Amendment-IV dated 23.04.2026 on the RFP Documents for Selection of Bidder as Transmission Service Provider to establish Inter-State Transmission system for “Transmission system for evacuation of power from Rajasthan REZ Ph-IV (Part-5: 6 GW) [Barmer Complex] Barmer-II: 6 GW (Solar) (LCC Configuration)” through tariff based competitive bidding process

Annexure-I

Proposed Communication for " Transmission system for evacuation of power from Rajasthan REZ Ph-IV (Part-5 :6 GW) [Barmer Complex] Barmer-II: 6 GW (Solar) (LCC Configuration)"

Figure F.1

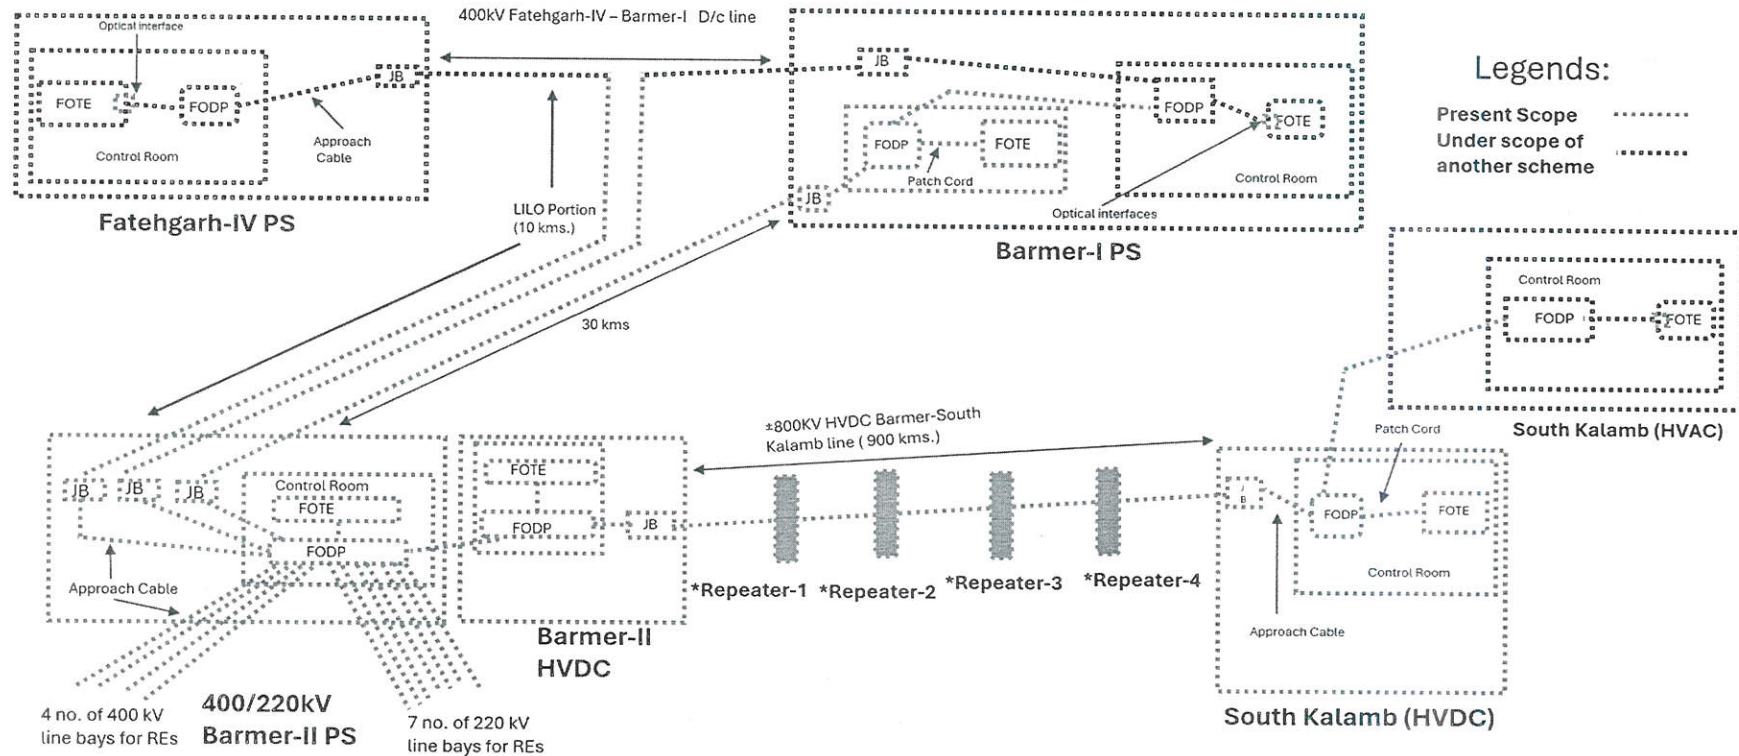
4.	Figure F.1 of Specific Technical Requirements for Communication	Figure F.1 indicating the proposed communication system for the scheme.	Revised Figure F.1 is attached at Annexure-I below.
